Request for Proposal (RFP)

Addendum No. 5

Project Name: N12(19-4)1,2&4

Owner: Navajo Division of Transportation

BRIDGE N504 PIPE
LAYOUT AND NOTES

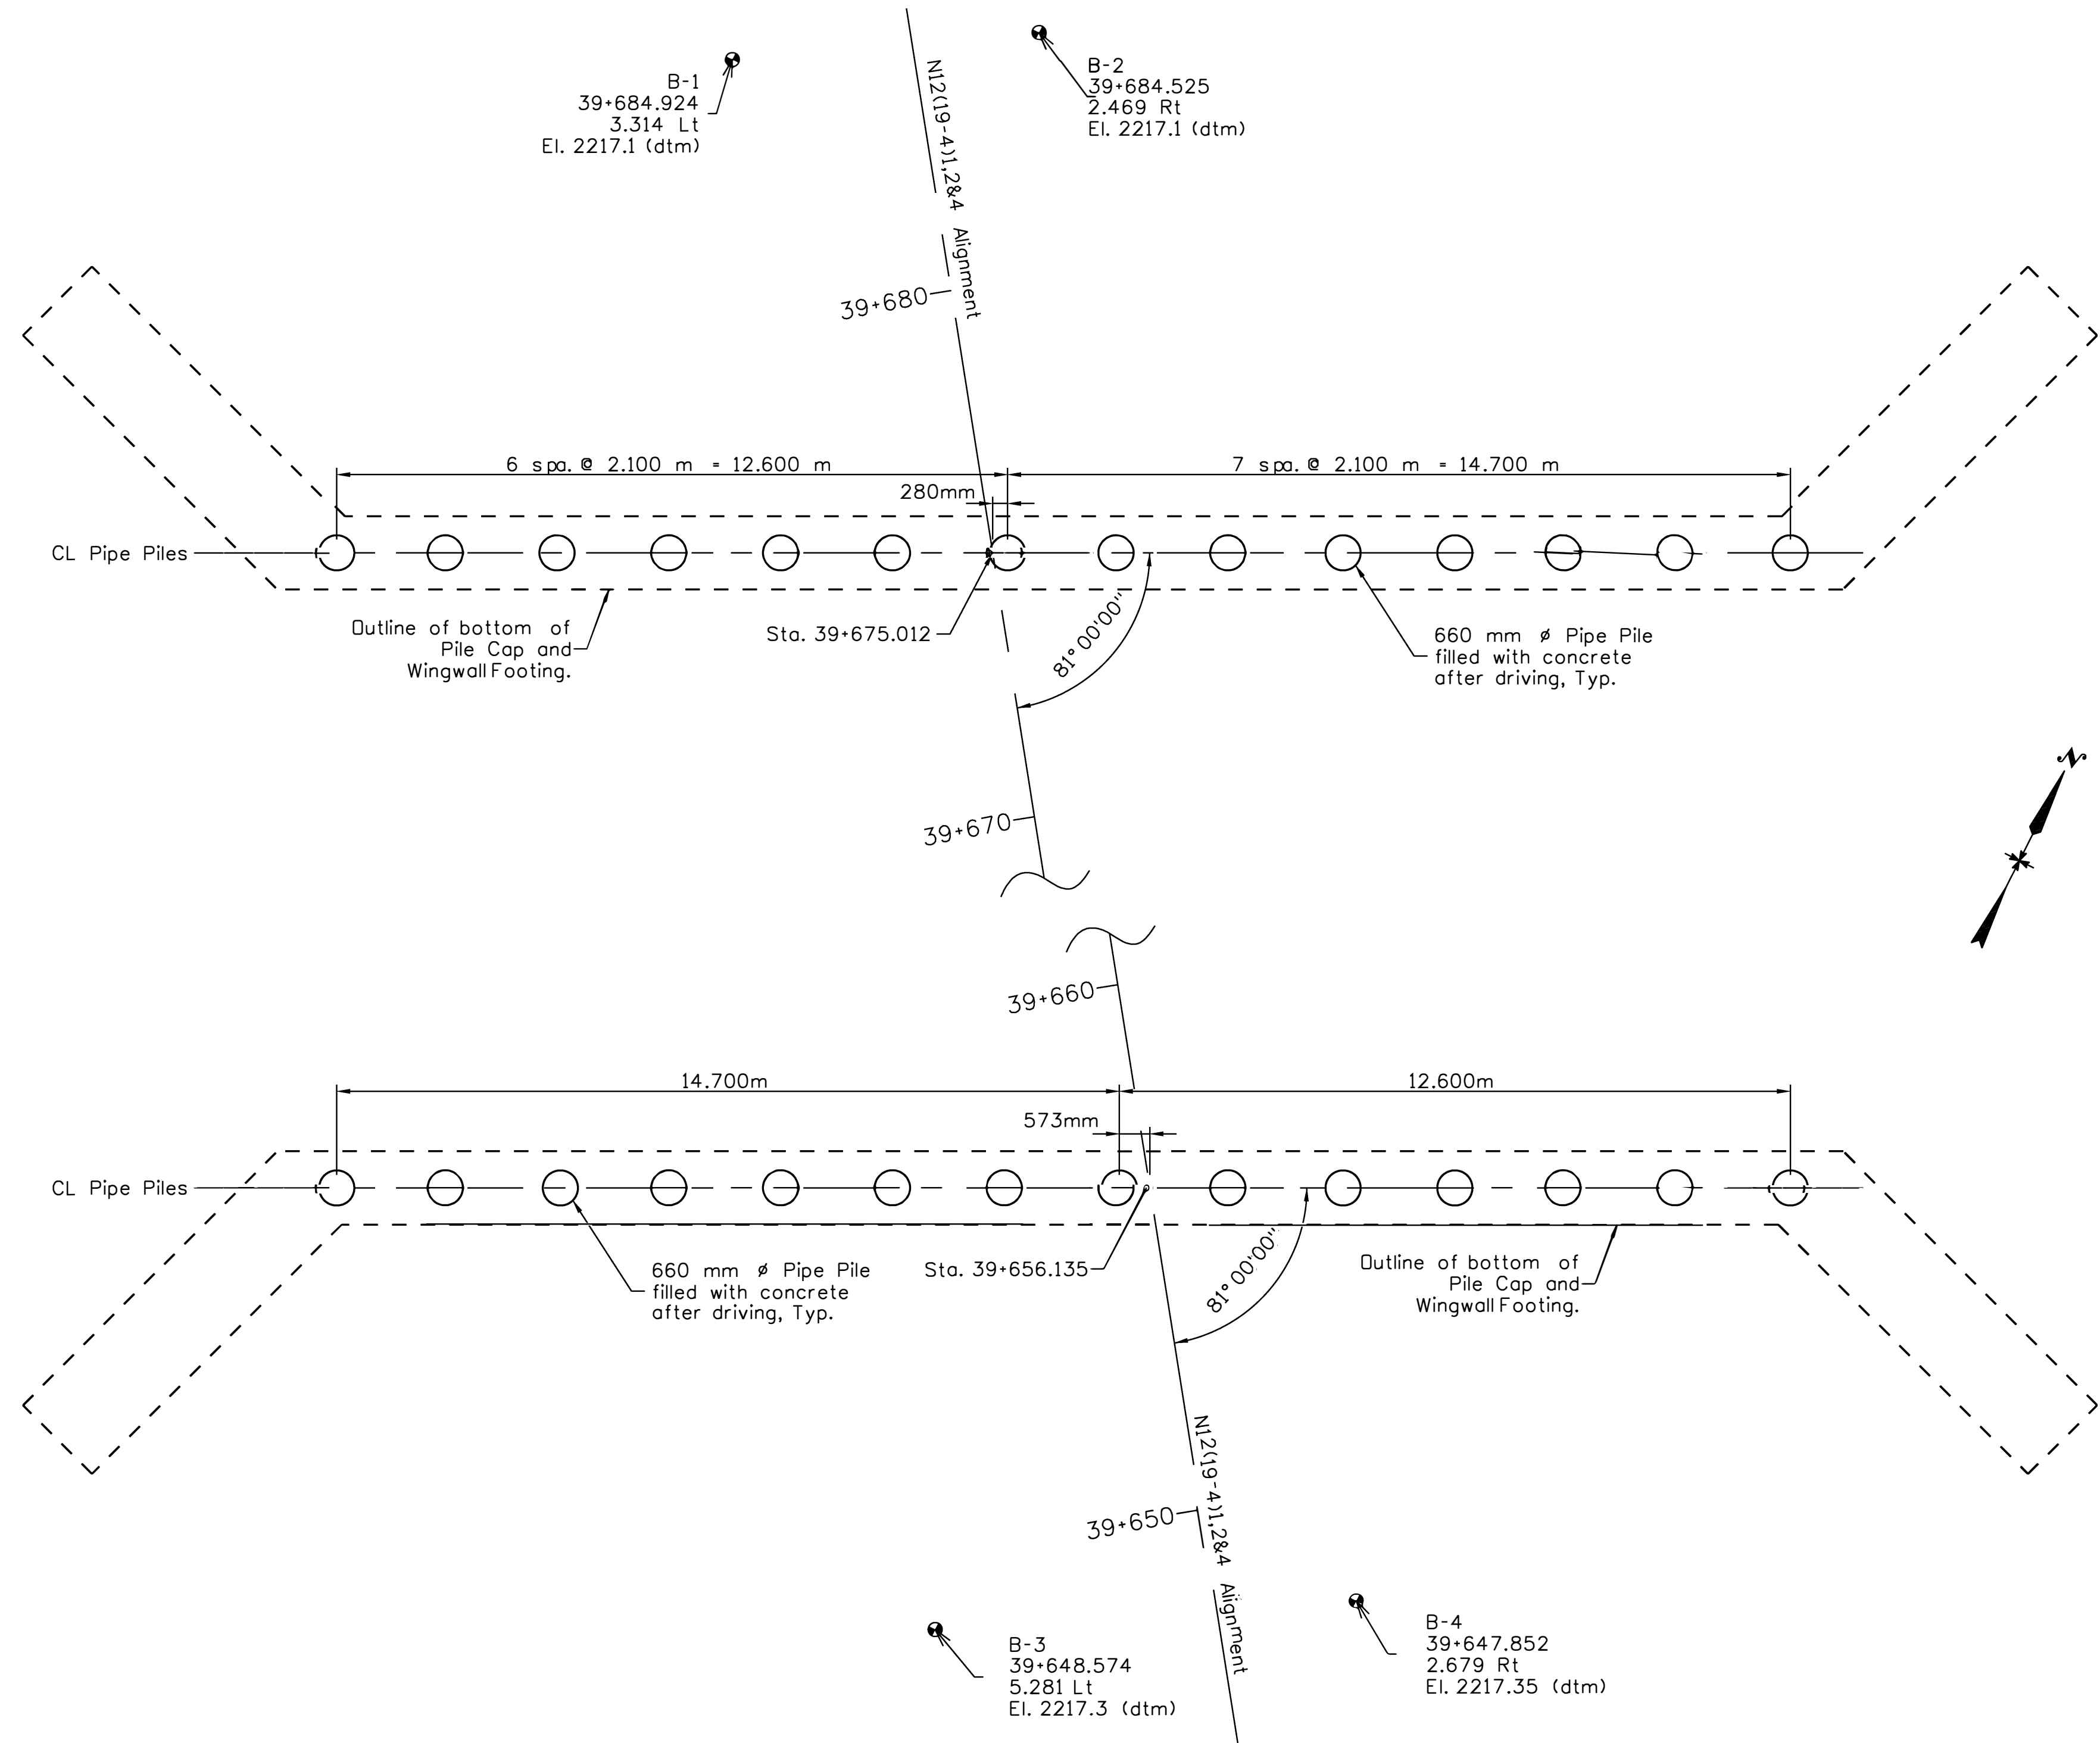
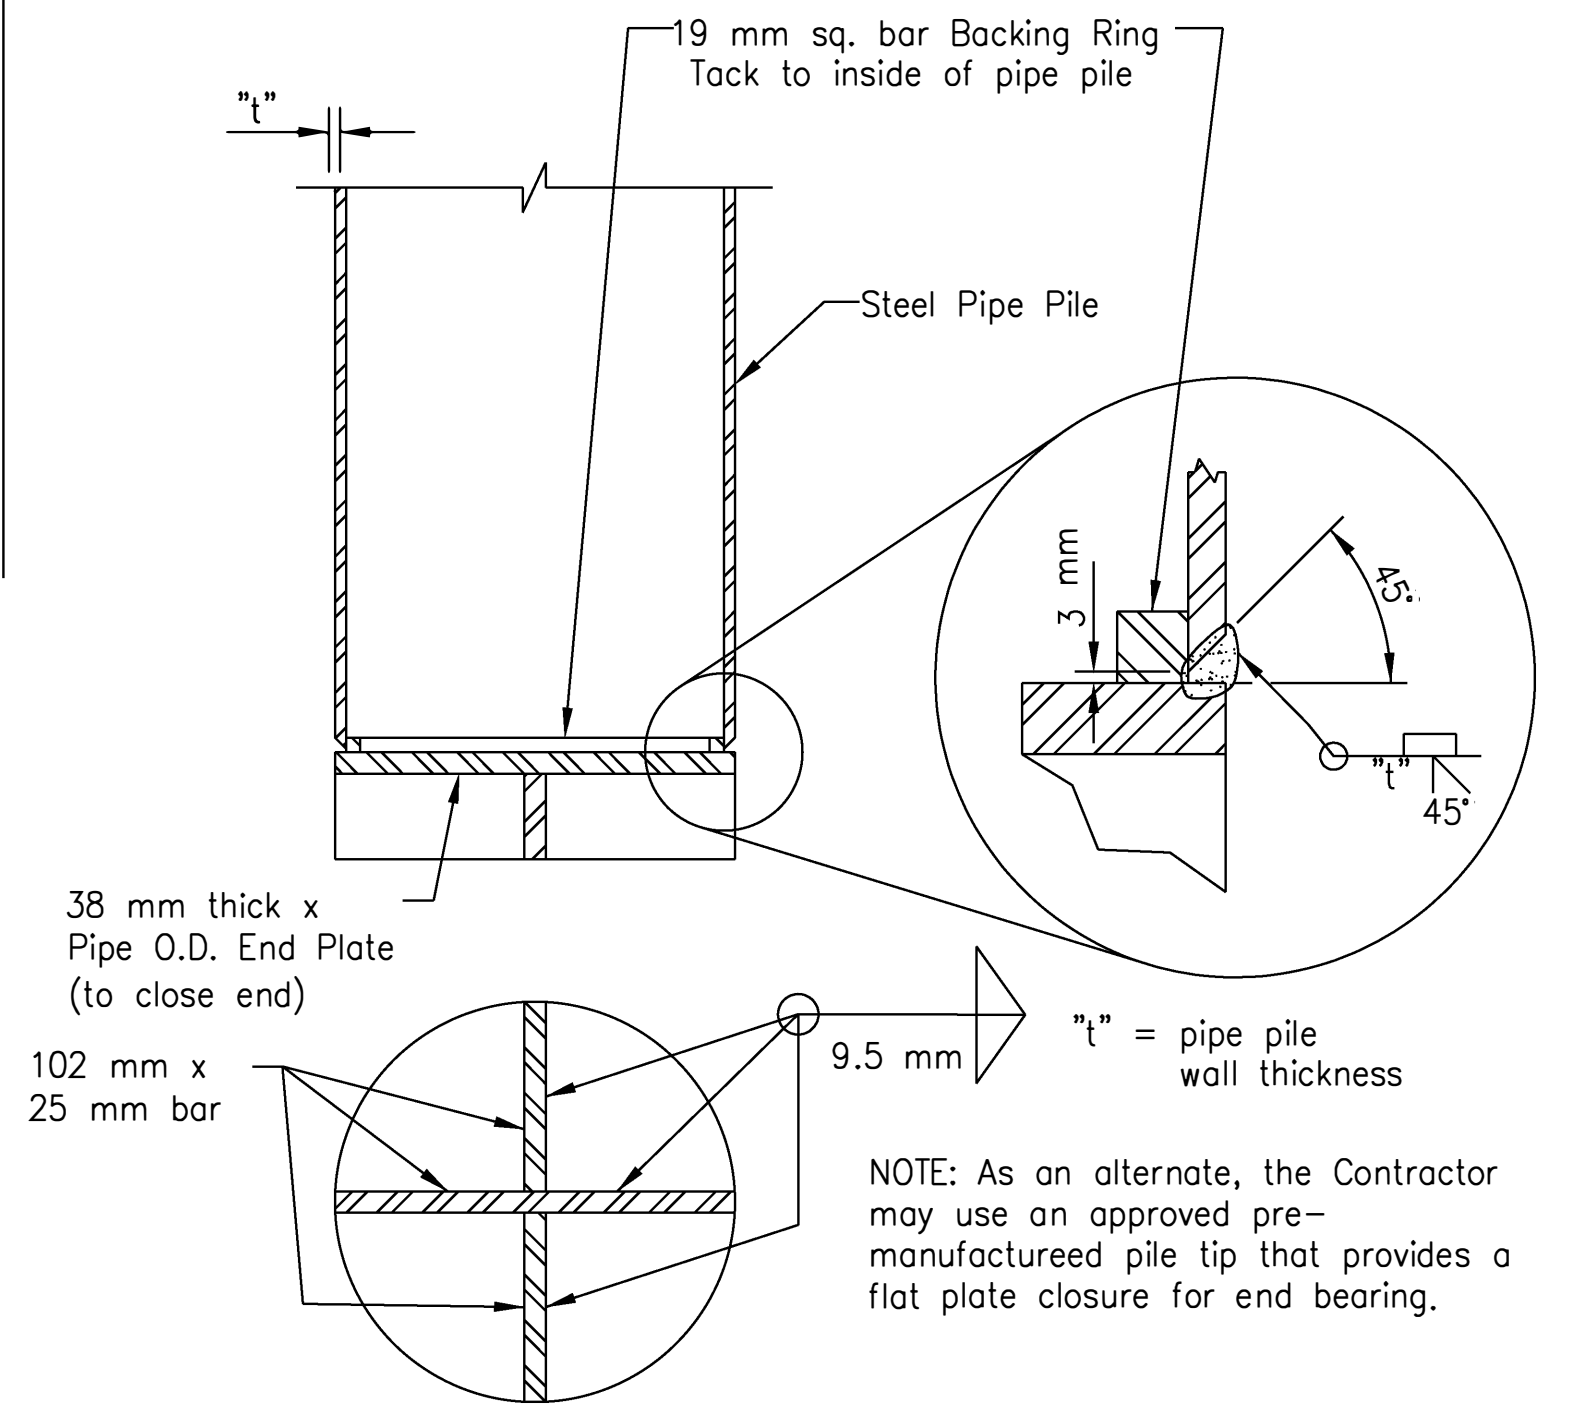
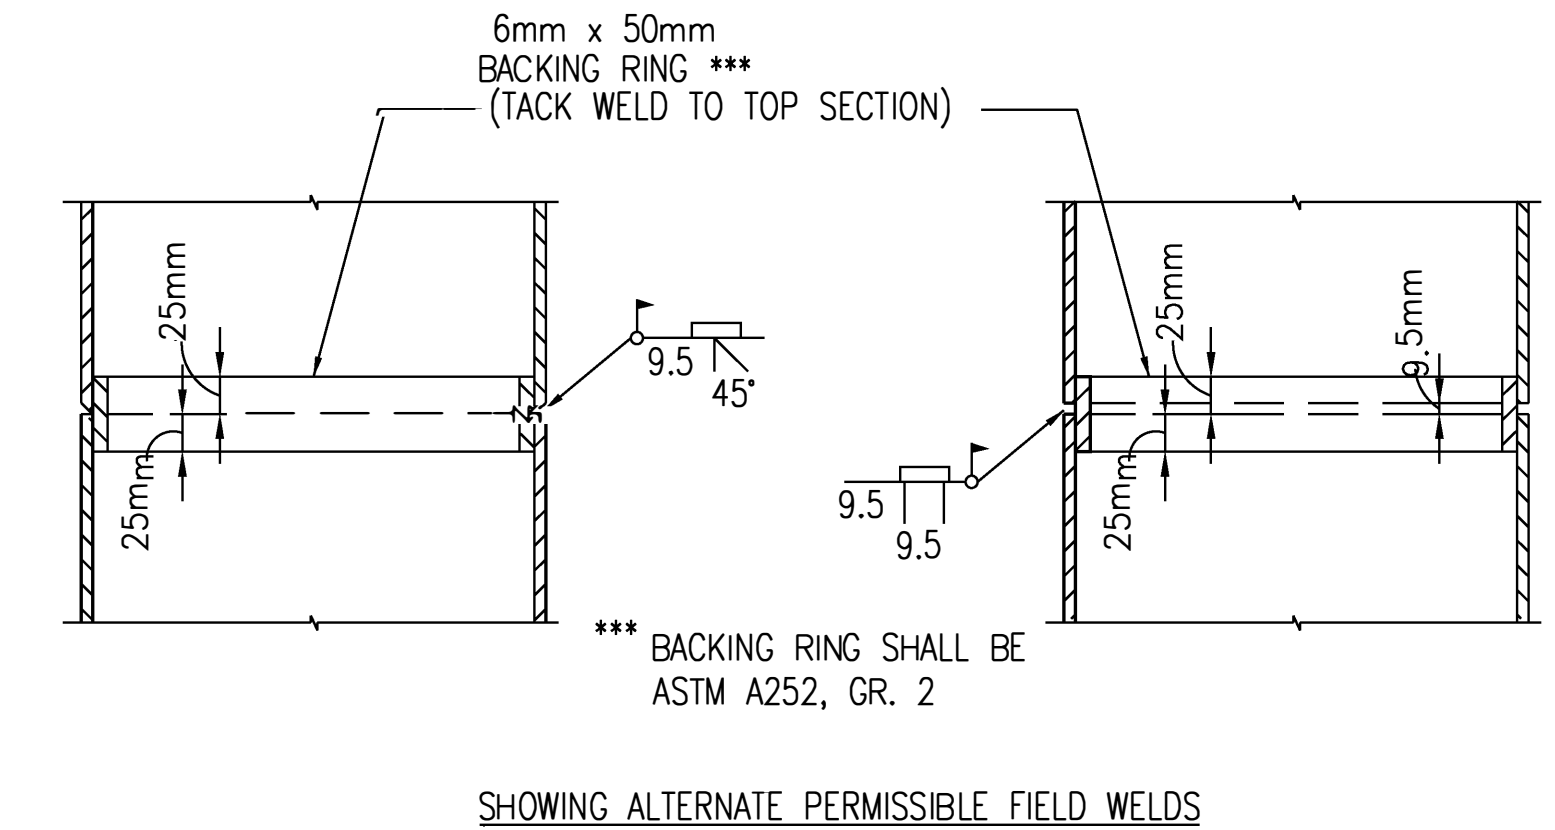
1. The BIA (Engineer of Record) has reviewed and revised two additional plan sheets (B-4 and B-5) based on the questions answered in Addendum No. 4. Please replace these two sheets in the N12(19-4)1,2&4 plan set. The revised plan sheets are attached to this Addendum No. 5 and the overall plan set PDF file has been updated as well.
